**BEFORE THE POLLUTION CONTROL BOARD
OF THE STATE OF ILLINOIS**

J.D. STREETT & COMPANY, INC.,)	
Petitioner,)	
)	
v.)	PCB 2018-003
)	(LUST Appeal)
ILLINOIS ENVIRONMENTAL)	
PROTECTION AGENCY,)	
Respondent.)

The Illinois Environmental Protection Agency (Illinois EPA) has reviewed the Corrective Action Plan (plan) submitted for the above-referenced incident. This plan, dated March 24, 2017, was received by the Illinois EPA on March 24, 2017. Citations in this letter are from the Environmental Protection Act (415 ILCS 5) (Act) and Title 35 of the Illinois Administrative Code (35 Ill. Adm. Code).

FIGURE 10: PROPOSED CORRECTIVE ACTION EXCAVATION
SCALE: 1" = 30' **DATE: 01-17-17**
J.D. STRETT & CO. (HERRIN #233)
701 S. PARK AVE. HERRIN, ILLINOIS

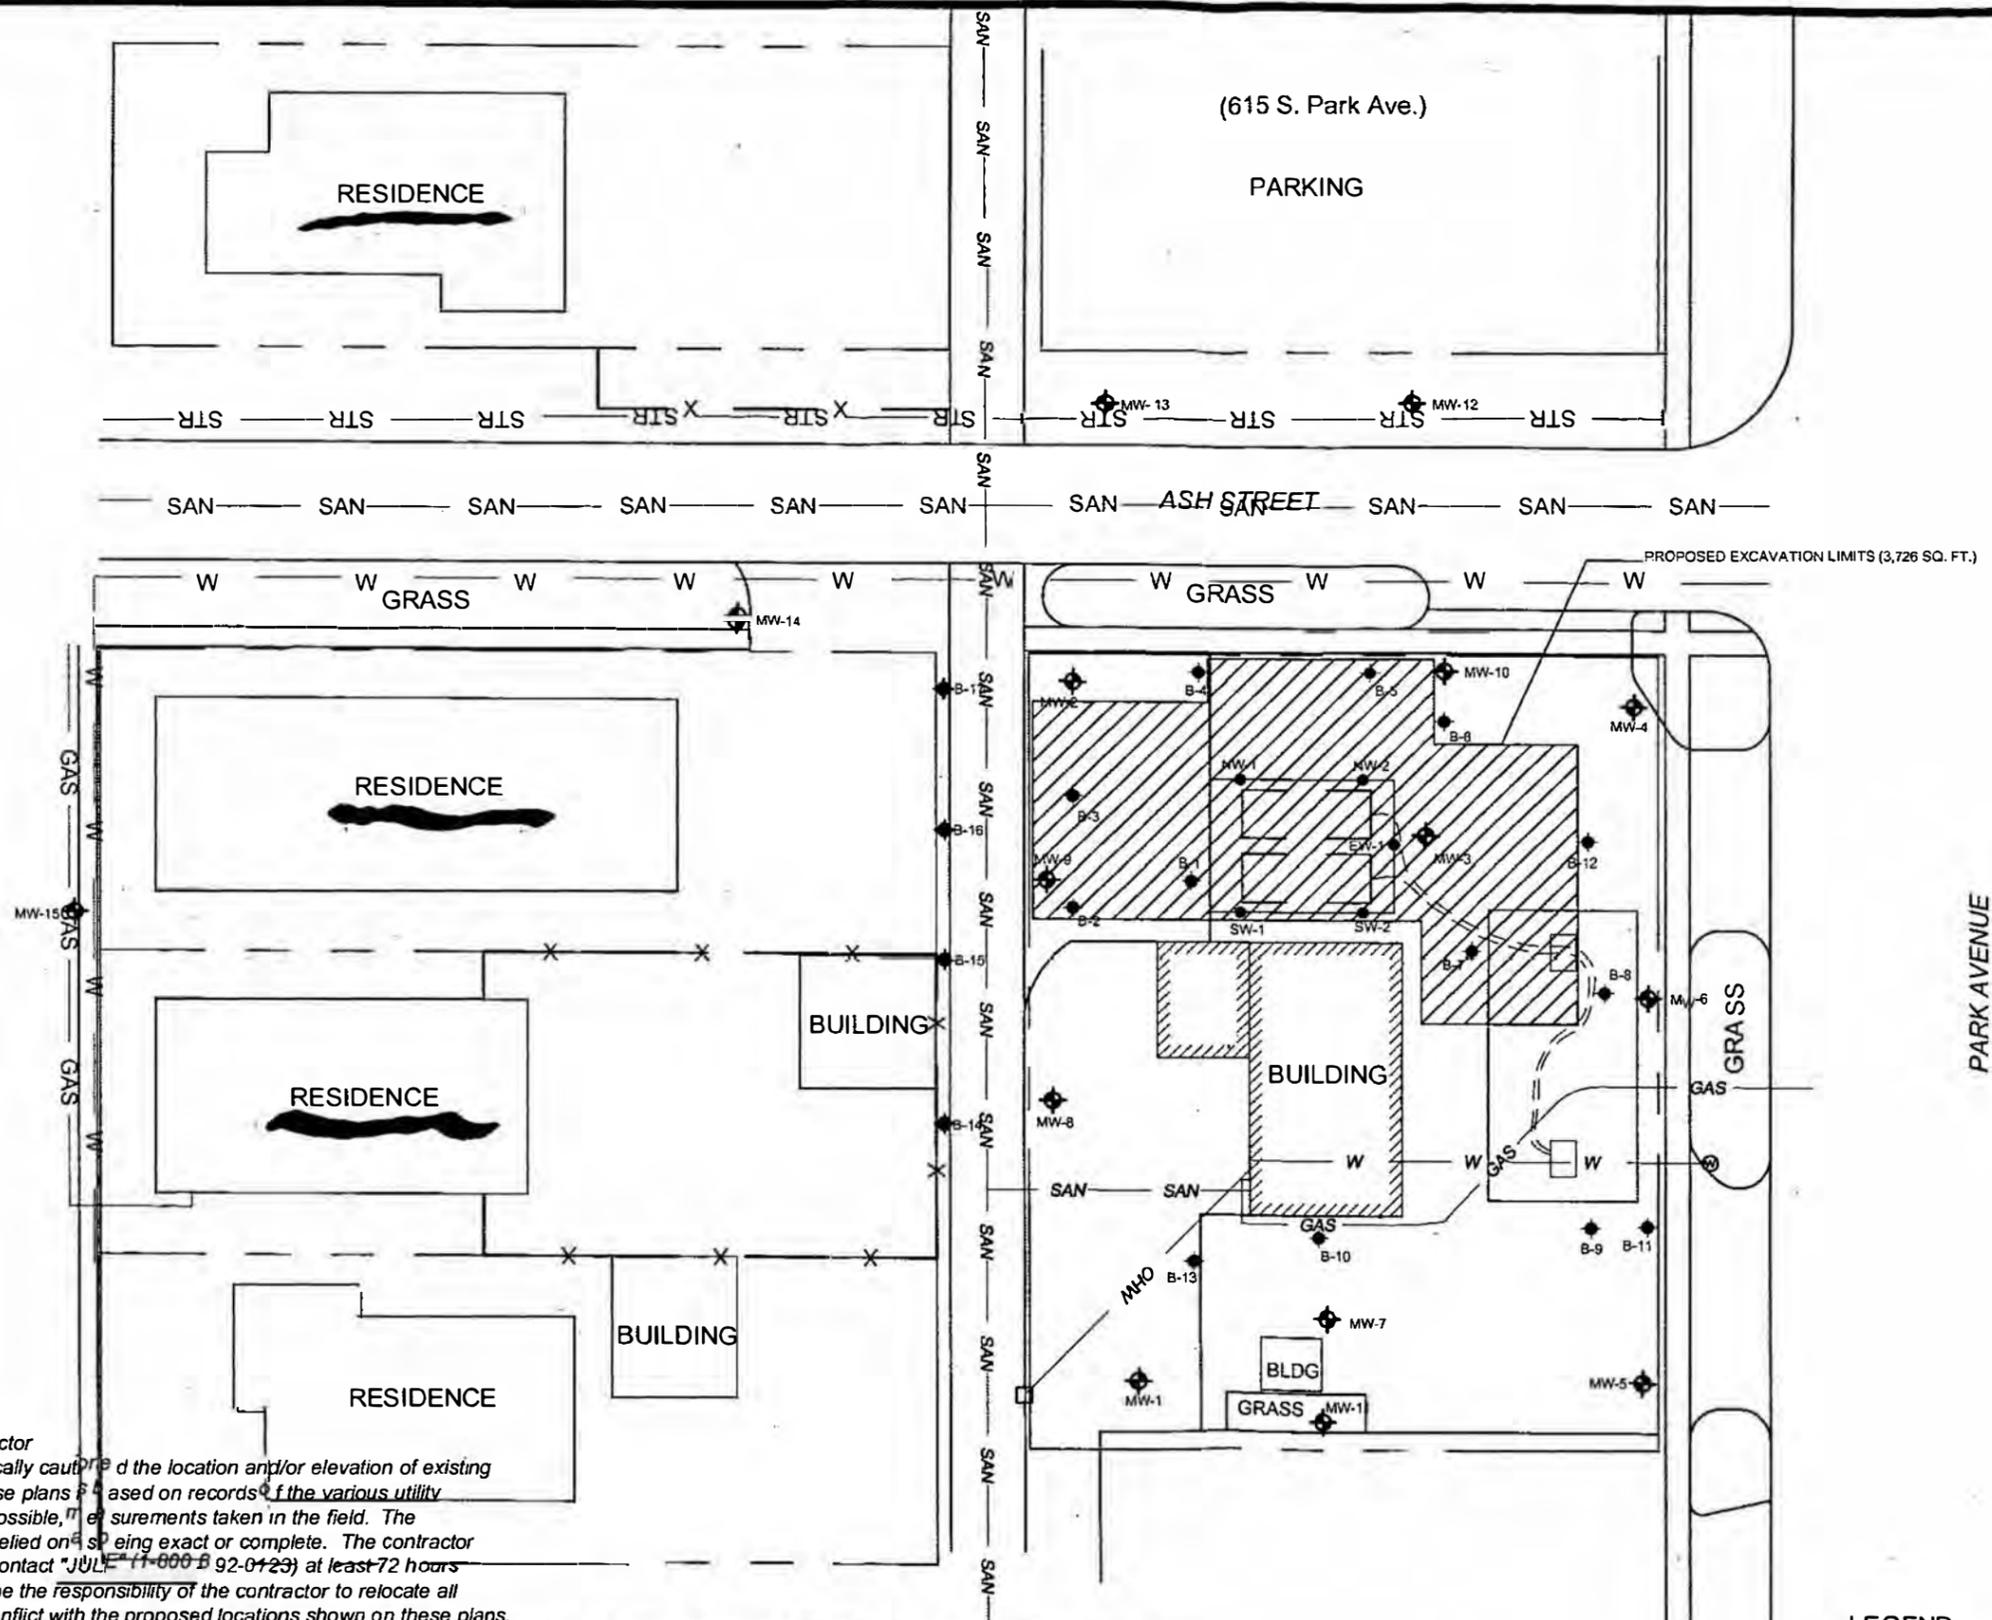
- Area of proposed excavation is 3,726 square feet (verified)
- A total of 23 soil borings were advanced on site—the average depth to groundwater in the soil borings was 6.2' bgs—a total of 8 soil borings were advanced off-site—the average depth to water in the off-site soil borings was 8.06' bgs—the plan proposes to excavate down to 9' bgs, which would more than likely remove soil from the saturated zone beneath the groundwater table

FIGURE 13: PROPOSED GW NOTIFICATION AREA BASED ON R-26
SCALE: 1" = 30' **DATE: 02-27-17**
J.D. STRETT & CO. (HERRIN #233)
701 S. PARK AVE. HERRIN, ILLINOIS

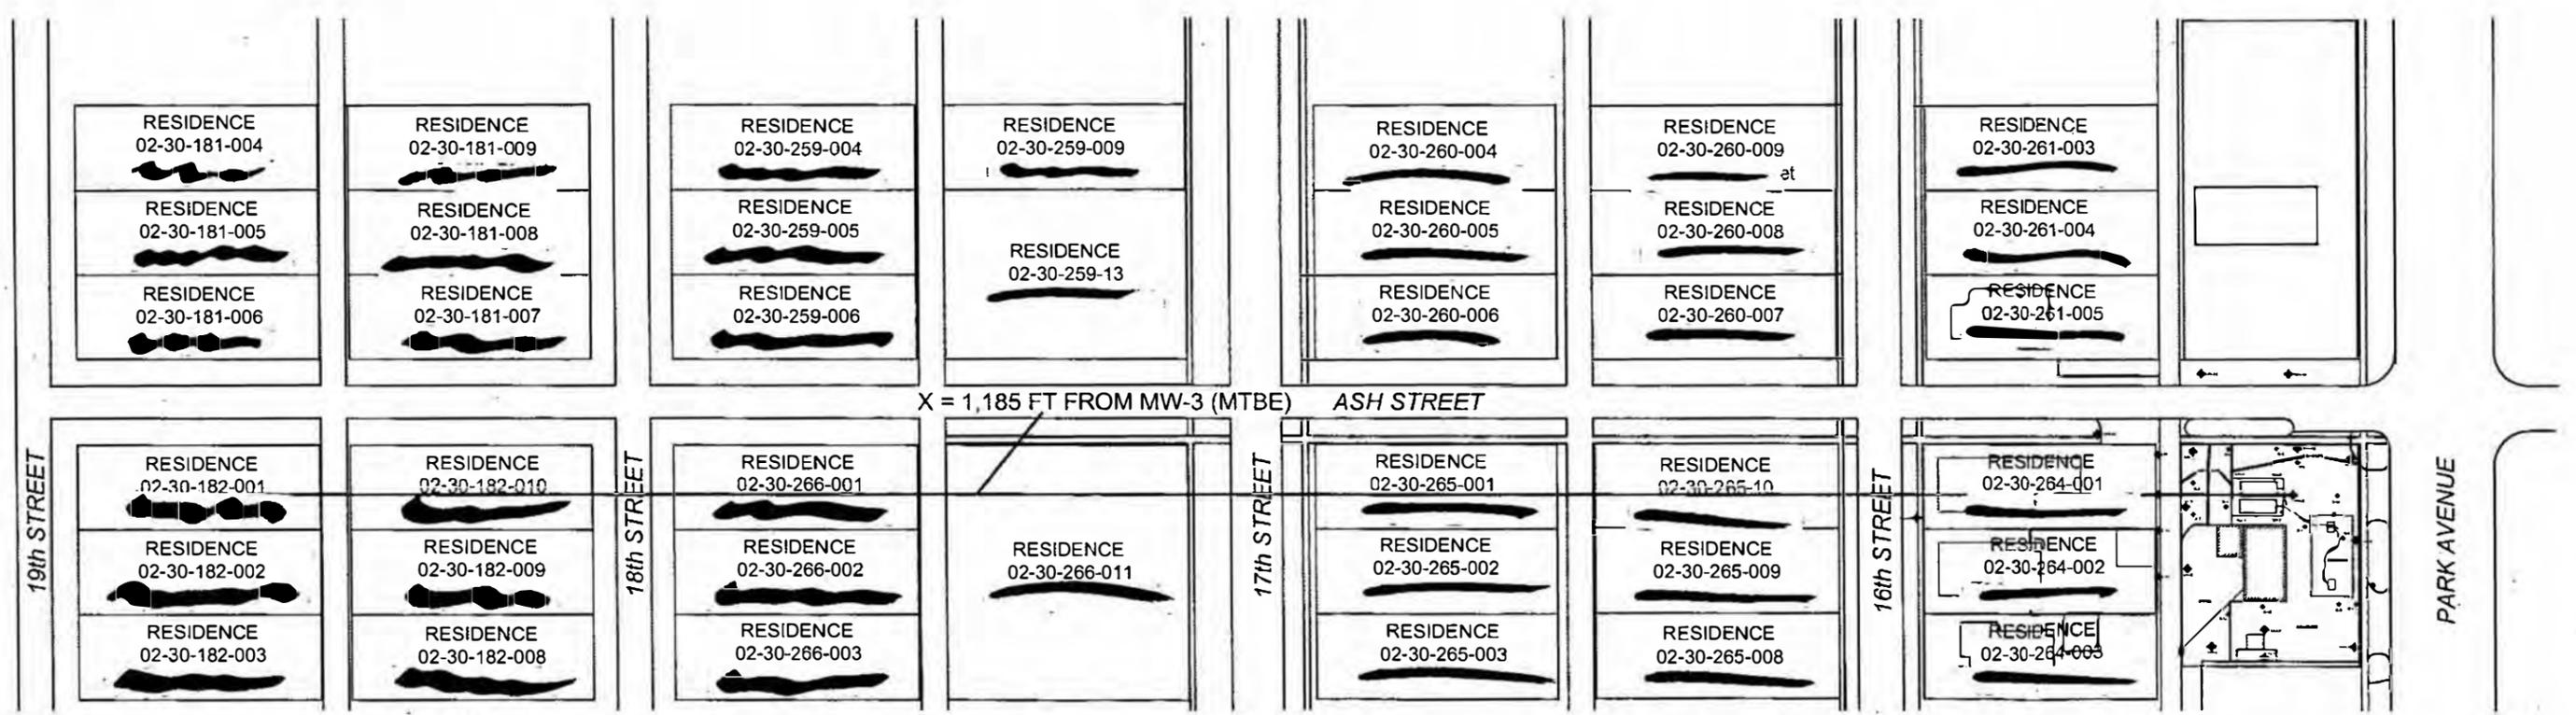
Figure 13 (8 hours) lists 39 properties anticipated to receive a notification letter. The map includes the addresses and the PINs for the (expected) affected properties. I went on the Williamson County website (http://bbamsoft.com/williamson1/web_list.php) and was able to find the owner of one of the properties very quickly. I can't imagine that it would take much time to get each owner's name from the website. The 40 hours for notification purposes seems unreasonable.
